Design Public Information Meeting Transcript

Route 7 Corridor Improvements Project

Project # 0007-029-942 & 0007-029-225, P-101, R-201, C-501, B-610, D-606, D-608

Index of Sheets

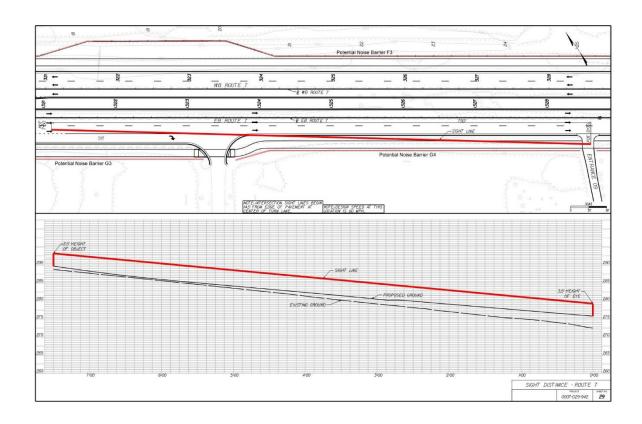
I was at the meeting last night, which answered a lot of questions while creating new ones for our property. I am very concerned about the safety of our driveway, which is called Entrance 9 on your plans. After reviewing carefully I can only conclude the following needs to be addressed:

- Driveway The driveway entrance currently is only wide enough for one car. Because our cars pull in / out of the driveway simultaneously, a noise wall would create a blind situation which could be quite dangerous. In short, nobody could see each other until the last possible moment. Currently this isn't a problem as we can see each other and pull off the road until one the driveway is clear. With the path this will no longer be an option.
- Noise Wall site limitations I would like to know how close they will be located to our
 driveway. Based on the drawings there are site limitations, both for the road and the pathway
 that crosses across our driveway. One of your engineers mentioned that we should have
 about 550 feet of site to judge traffic. Can you confirm this is accurate.

I'm open to all solutions, but just don't want a dangerous situation created that can be avoided with a bit of forethought.
	I can be reached at willaweiss@gmail.com or 703-282-3328.
	I look forward to hearing from you.
	Ţ.,
	Take care,
l,	Will Weiss
Tal	ke care,
Wil	I

Response: The proposed entrance will have a width of 16' across the shared use path and up to the face of the proposed noise barriers. From there it will gradually transition from 16' to approximately 12' to match the existing driveway width. Both the existing driveway and proposed driveway slope are and will be approximately 22%, however a wider flat spot, or landing, will be provided adjacent to Route 7 than the current condition in order to accommodate the shared use path and graded buffer strip. Vehicles will need to approach the top of the driveway with caution, but there is adequate distance to make a decision to enter Route 7 once at the top of the driveway.

Response: The ends of both potential noise barriers are shown to be located approximately 4' from the edge of both sides of the driveway. Sight lines for turning vehicles are established at a point 14.5' from the edge of the travel lane. Due to the width of the shared use path and buffer area, this 14.5' is located in front of the noise barriers. Based on the 60mph design speed and grade/slope of Route 7, the sight line profile for this entrance has been analyzed for 750' of sight line. The attached profile shows the proposed grade below this line of sight and shows that it will be possible to see at least 750' to the west of the driveway when vehicles are pulling out of the entrance.

I've also attached the design sheet that illustrates the driveway and sight line.
